# COMMISSION ACTION

NCPC File No. 6614

**WASHINGTON NATIONALS BASEBALL STADIUM**  
South Capitol Street and Potomac Avenue, SE  
Washington, D.C.

# STAFF RECOMMENDATION

Fig 5 Perimeter Security

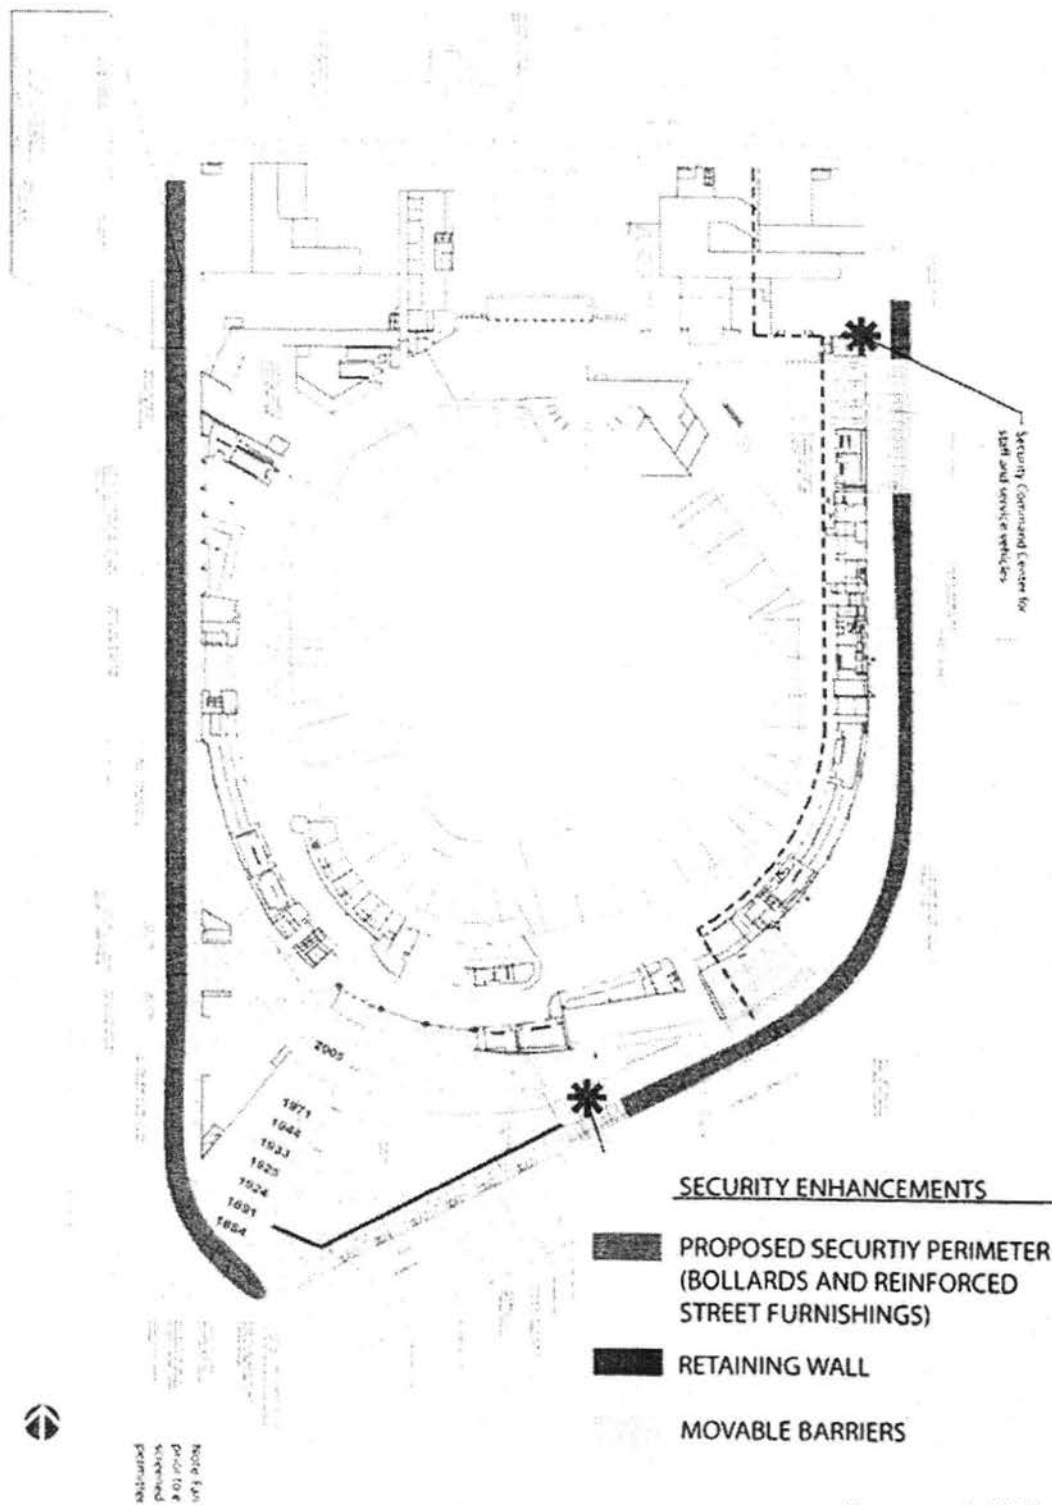
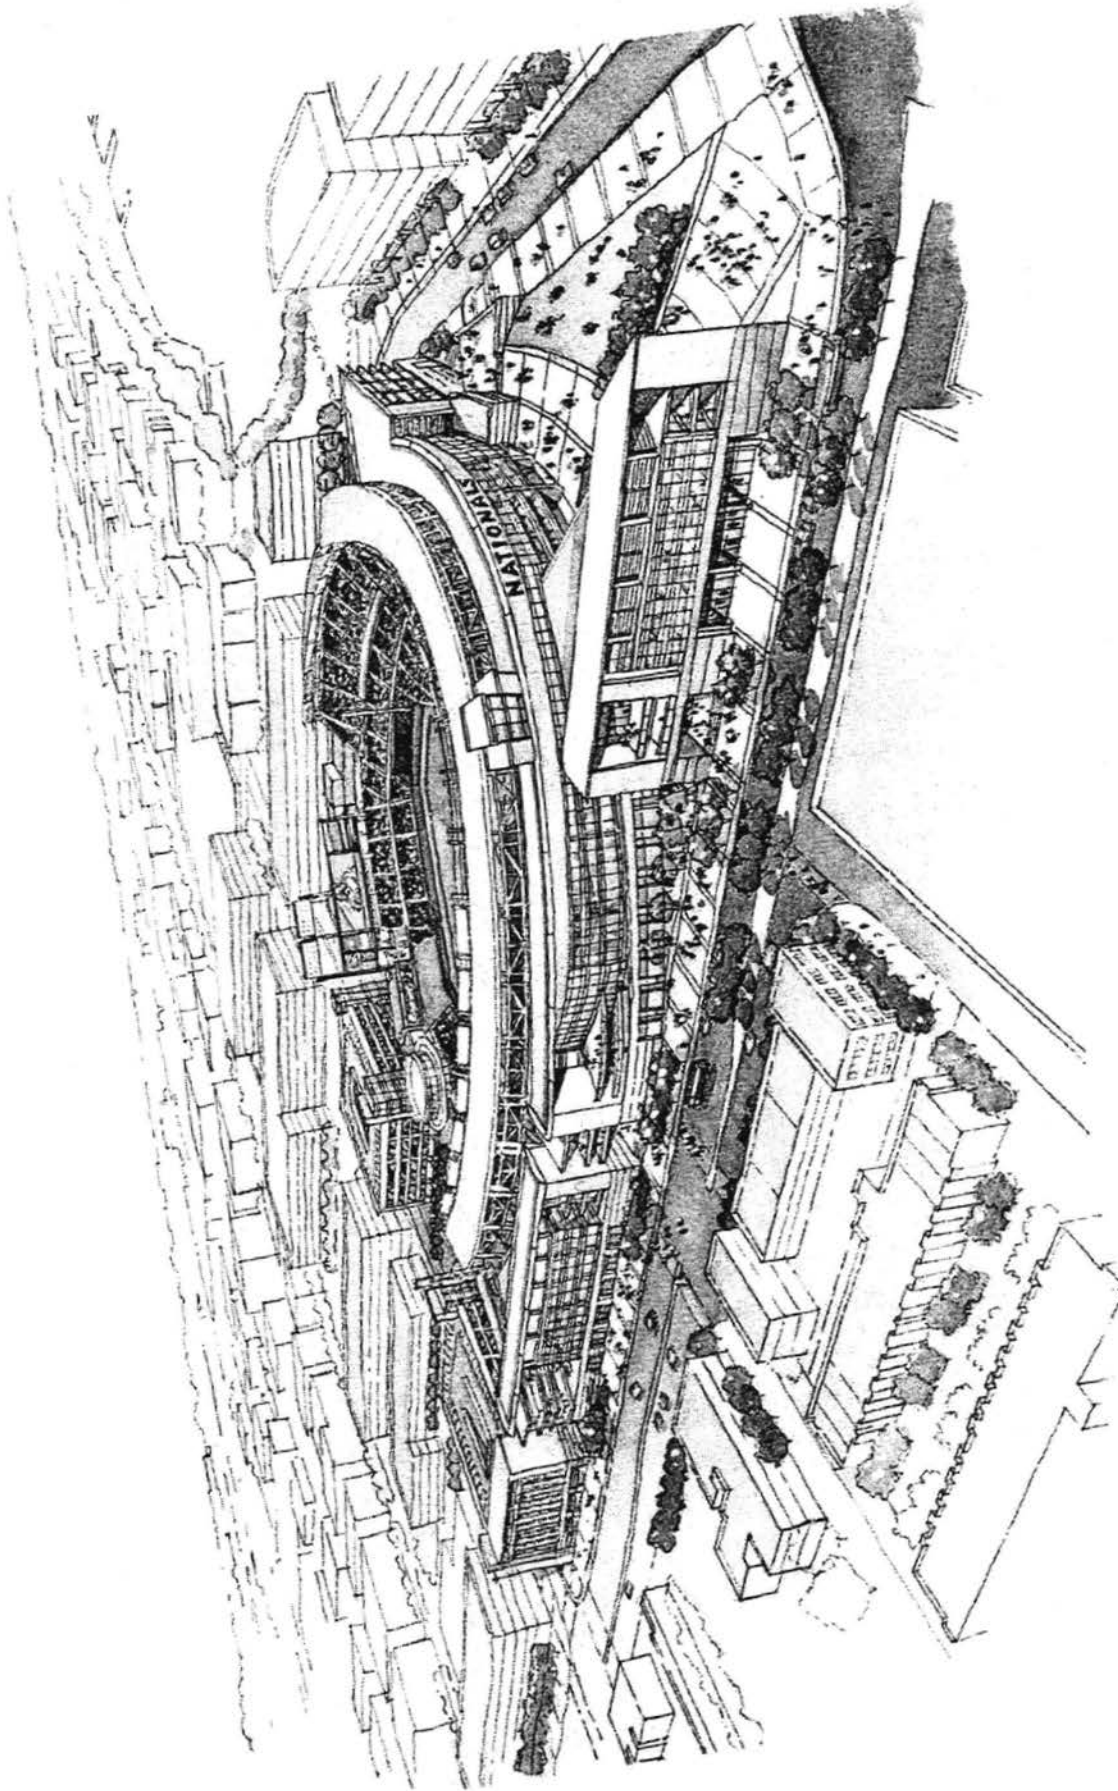
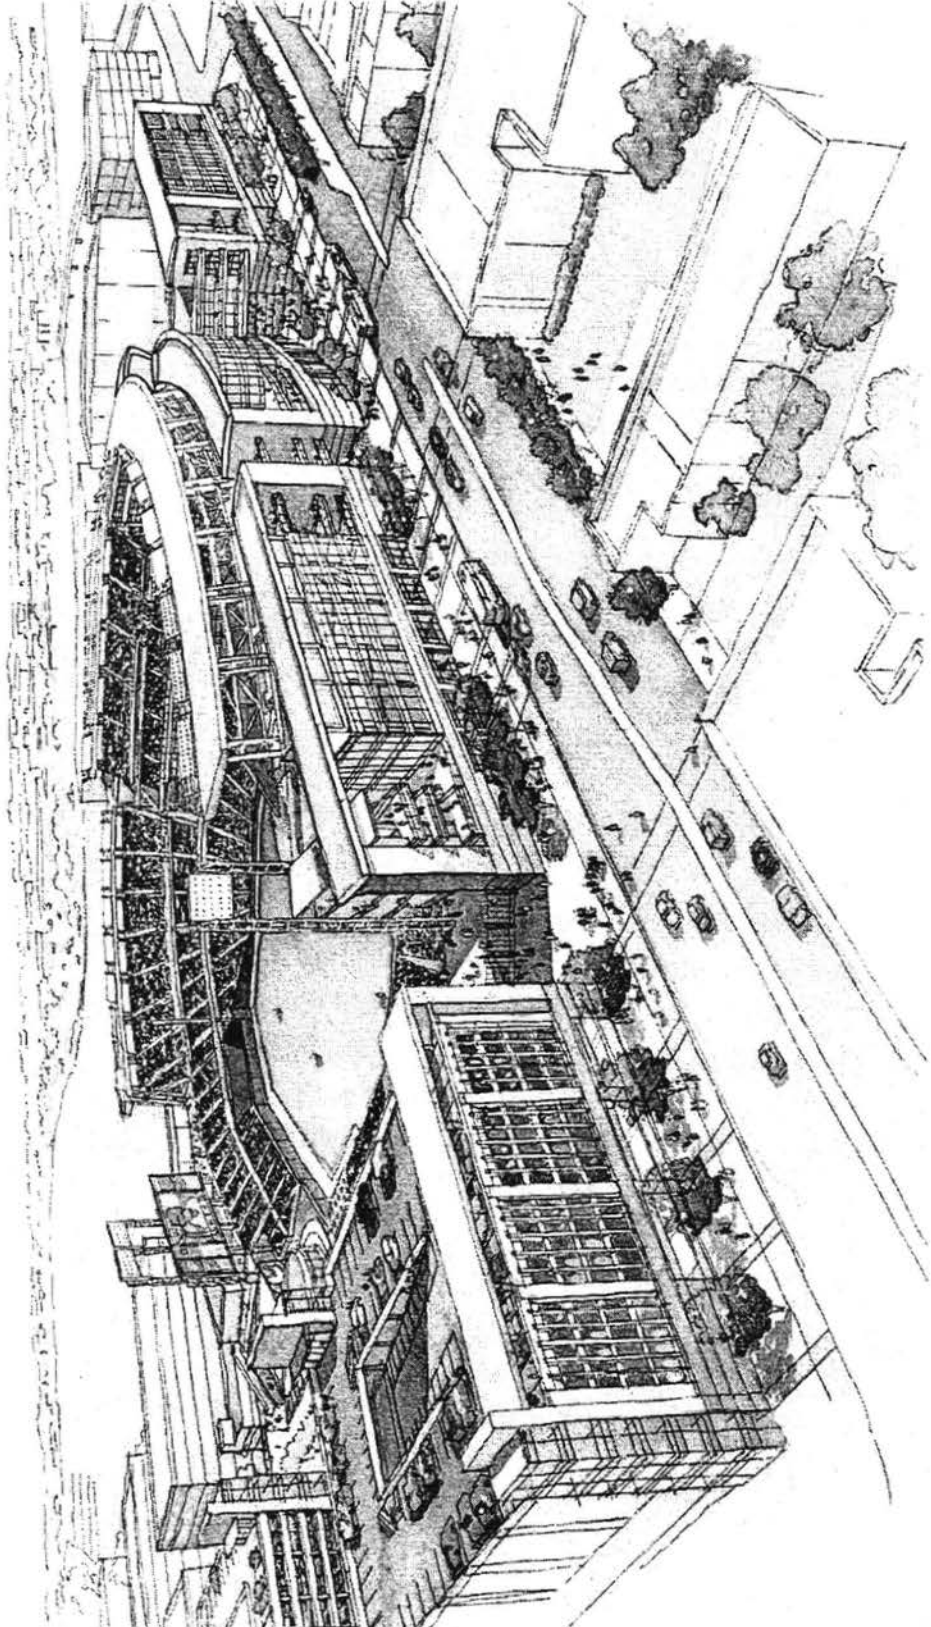
The applicant has performed a risk assessment and has noted the intention to provide perimeter security in accordance with the National Capital Urban Design and Security Plan. However, the submission does not provide detail design and specifications of the elements or include supporting documentation to evaluate primary objectives. Furthermore, the Urban Design and Security Plan does not include a design framework for perimeter security along South Capitol Street. **Staff recommends that further information be provided regarding the justification for and design of perimeter security elements.**

- Exterior illumination of the ballpark
- Sports lighting
- Monumental naming rights sign and other exterior entrance signage
- Scoreboard
- Ground floor building uses and façade articulation along South Capitol Street
- Perimeter security
- Second Phase building site and building design

Fig 16 Base Plan and Opt 1 & 2  
Preferred Uses – Main Concourse Level

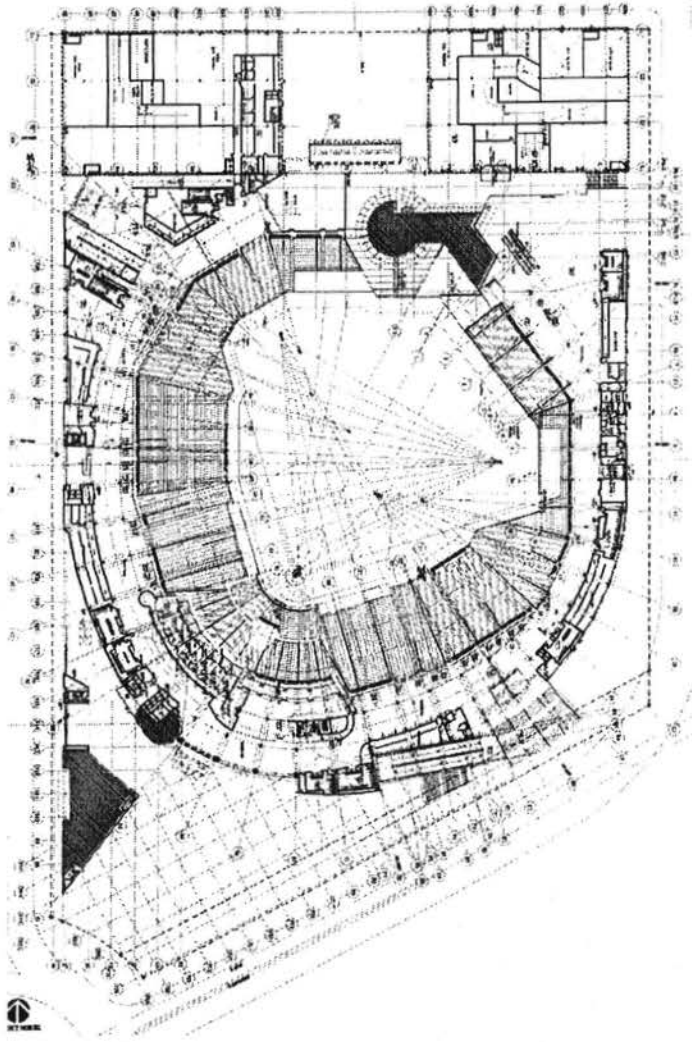
Staff supports the Zoning Commission's requirement that "not less than twenty percent of the Ballpark building's exterior perimeter frontage... be devoted to retail, service, entertainment, or arts uses (preferred uses)..." A variety of preferred uses should be maximized to the greatest extent possible around the entire site in order to promote and sustain active street life during game days and especially during non-game days. The Base Plan will provide approximately 10 percent of the perimeter for preferred uses however, for the most part, they will be Ballpark functions, such as ticket booths, team store and baseball offices which will support minimal non-game day activity. The proposed center field restaurant will be located internally to the Ballpark and not be seen from the perimeter. The nine consecutive service bays and wide driveway apron along First Street will not promote pedestrian activity and denote the back-of-house. Options 1 and 2 will exceed the 20 percent minimum for preferred uses and will invigorate and promote street activity on First Street during game days and non-game days. However, the ground level of the proposed administration building provides the largest preferred use on South Capitol Street in the Base Plan or in Options 1 and 2. **Staff does not support providing the applicant with relief from current zoning requirements for preferred uses and recommends that additional preferred uses be located along South Capitol Street in order to activate and support street life during non-game days. Further information on uses and building façade articulation along South Capitol Street should be submitted.**

- Option One and Option Two be implemented.
- Twenty percent of the ground floor of all new buildings be devoted to retail and other public uses as required in Capital Gateway Overlay District, particularly along South Capitol Street, in order promote and sustain active street life especially during non-game days.
- Parking facilities for both passenger vehicles and buses be located interior to the Ballpark site and below ground.

Fig 21 Sports Lighting

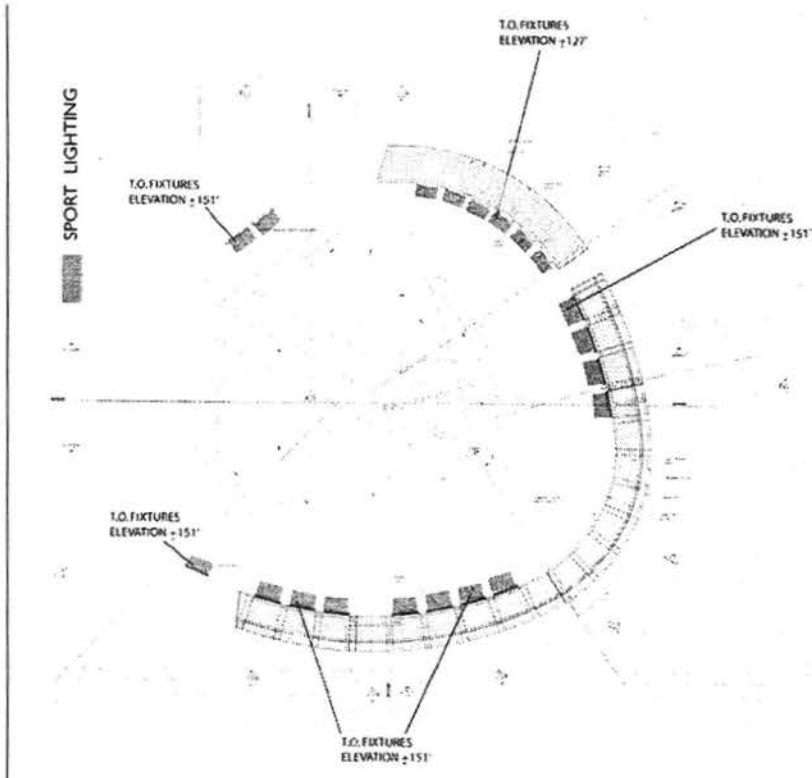
The submission did not include any design and specifications for the general illumination of the ballpark exterior. The applicant has noted that the proposed ballpark building mass will help minimize the light spill from sports lighting; however, light will emanate towards the north and east of the site where the ballpark massing is lower. Staff notes that the height of future development around the ballpark site may minimize the light spill in this area. Staff recommends that the applicant submit further information, including photo simulations and footcandle modeling for exterior illumination of the ballpark and sports lighting, so that the Commission can evaluate the impact of lighting upon nighttime vistas and viewsheds to and from the Capitol and the Anacostia River.

Fig 20 Signage

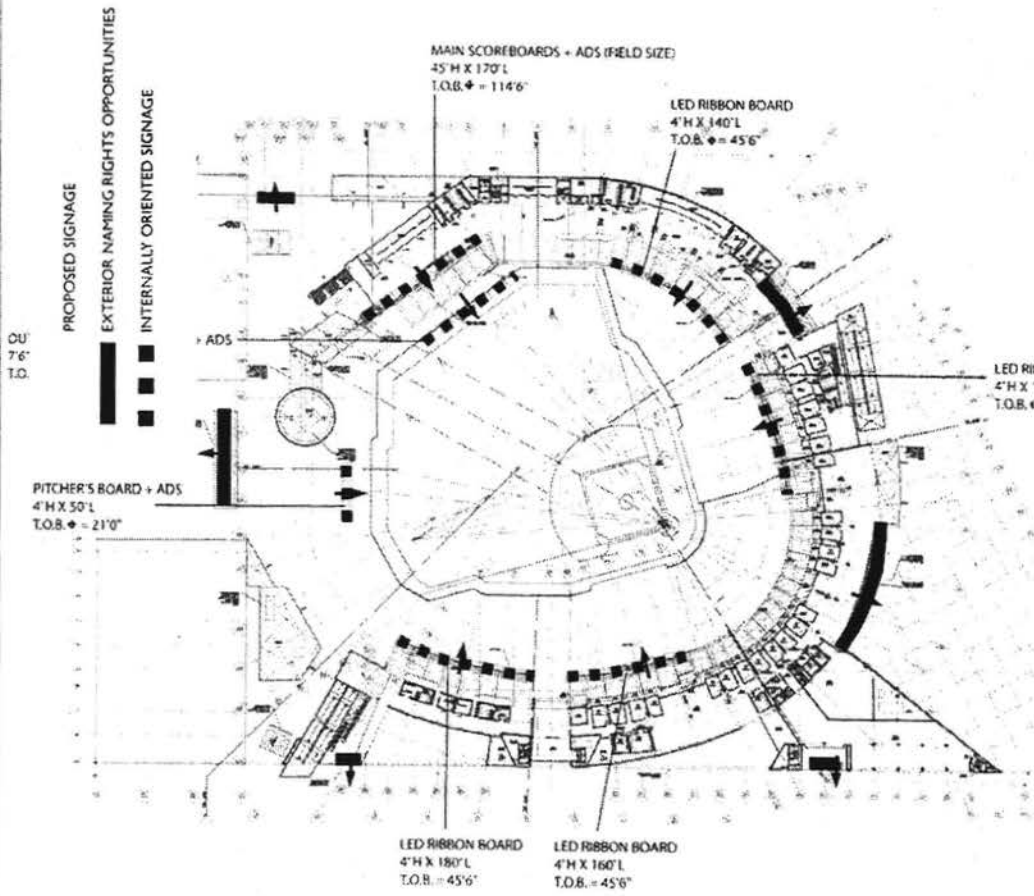
The location and design of the proposed monumental naming rights sign, that will be located on the curving upper concourse façade facing south to Potomac Avenue, will have significant impacts upon the skyline and vistas of the Capitol and monumental core from the Frederick Douglas Bridge, the South Capitol Street gateway, the Anacostia River, the Anacostia ridgeline, Interstate 295 and federal installations and neighborhoods located on the eastern side of the Anacostia River. The submission did not include any design and specifications for any other exterior signage surrounding the ballpark. **Staff recommends that the applicant submit the design and specifications of the proposed monumental naming rights sign and all other illuminated exterior signage, in particular those that will be located adjacent to public entries, in order to evaluate their impacts upon vistas and viewsheds to the Capitol, monumental core and areas immediately surrounding the Ballpark site.**

The applicant did not include the design of the scoreboard, both front and back, with the submission. The proposed scoreboard will not be seen from certain exterior locations with higher building massing, such as the curved upper deck and upper concourse building. However the scoreboard will be seen from various visual penetration points through the ballpark as well as from the north and east of the site where the ballpark massing is lower. Staff notes that the height of future development around the ballpark may diminish these views. **Staff recommends that the applicant submit the scoreboard design in order to evaluate its visual impact upon vistas and viewsheds as well as from areas immediately surrounding the Ballpark site.**
